Jacobsen Service Bulletin

Product Type: Leo/Estate

Bulletin No: **C-148-03**

17.5 Briggs & Stratton Engine

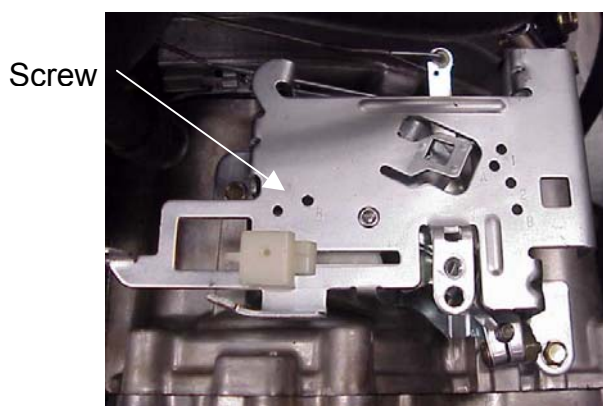
Units may have been shipped without choke-a-matic stop screw removed or missing linkage.

Check to see if the stop screw is installed, if the stop screw is installed please remove and discard it. If the choke link is not installed on engine, call the Johnson Creek Customer Service Department at 1-800-848-1636 option 2, 2. They will send you the choke link and instructions you need to do the repair.
